Access Compliance Report

Public Rights-of-Way

(Curb Ramps)

Intersection ID: 3322	Main Street: CANTERBROOK_DR	Cross Street: TURTLE_CROSS_LN	Location: NW
ADA ID: B90B55E02562	Ramp Type: Perp	Initial Pass/Fail: Fail	Overall Compliance: No
Severity Score: 18.75			
Codes/Mitigation Info/Possible Solution		Field Measurements/Component Compliance

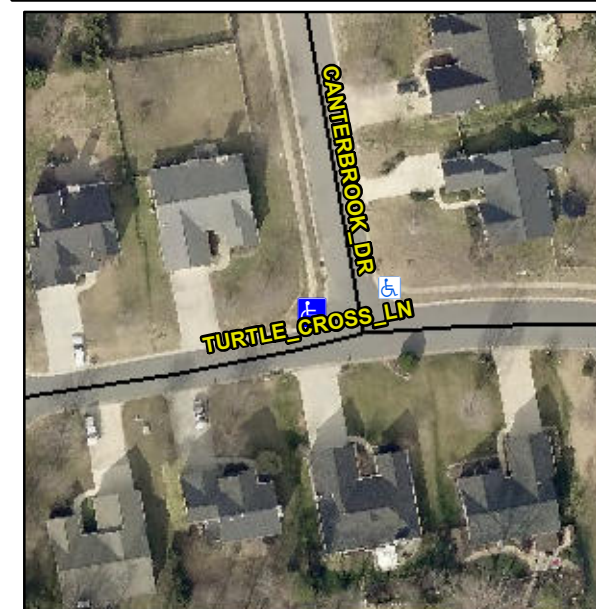
R304.5.1, R304.5.3

Compliance	Description	Data	Compliance	Description	Data
N/A	Ramp Length (in)	48.0	Yes	Ramp Slope (%)	5.0
No	Ramp Width (in)	34.0	No	Ramp XSlope (%)	2.9
N/A	Flare Type LT	N/A	N/A	Flare Type RT	N/A
N/A	Flare Slope LT (%)	N/A	N/A	Flare Slope RT (%)	N/A
N/A	Flare Traversable LT?	N/A	N/A	Flare Traversable RT?	N/A
N/A	Landing Length (in)	N/A	N/A	DWS Provided?	N/A
N/A	Landing Width (in)	N/A	N/A	DWS Contrast?	N/A
N/A	Landing Slope (%)	N/A	N/A	DWS Length (in)	N/A
N/A	Landing X Slope (%)	N/A	N/A	DWS Full Width?	N/A
N/A	Landing Curb? (Y/N)	N/A	N/A	DWS Offset (in)	N/A
N/A	Shared Landing?	N/A			
N/A	Gutter Ponding?	N/A	N/A	Gutter Slope (%)	N/A
N/A	Gutter Lip Ht (in)	N/A	N/A	Gutter X Slope (%)	N/A
N/A	Painted X Walk1?	No	N/A	Painted X Walk2?	N/A
	X Walk 1 Direction	To E		X Walk 2 Direction	N/A
N/A	X Walk 1 Width (in)	N/A	N/A	X Walk 2 Width (in)	N/A
	X Walk 1 Slope (%)	0.8		X Walk 2 Slope (%)	N/A
	X Walk 1 X Slope (%)	2.4		X Walk 2 X Slope (%)	N/A

Remove & Replace Entire Ramp.
